CITY OF Clemson SOUTH CAROLINA

ADDENDUM #3 02/27/2024

INVITATION TO BID ENTRYWAY SIGN FABRICATION AND INSTALLATION

Sign 1: HWY 123 @ Issaqueena Trail Exit Ramp

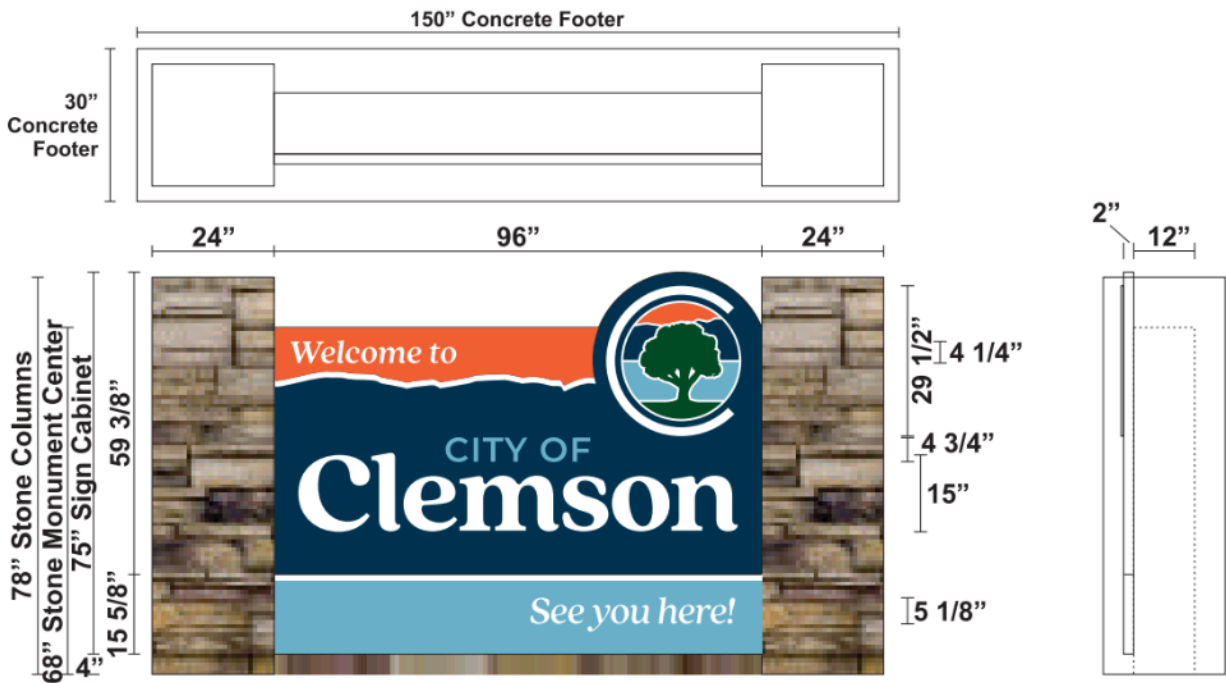
19. Does the height 120" include the logo circle?

Specs for all signs can be found on the next two pages.
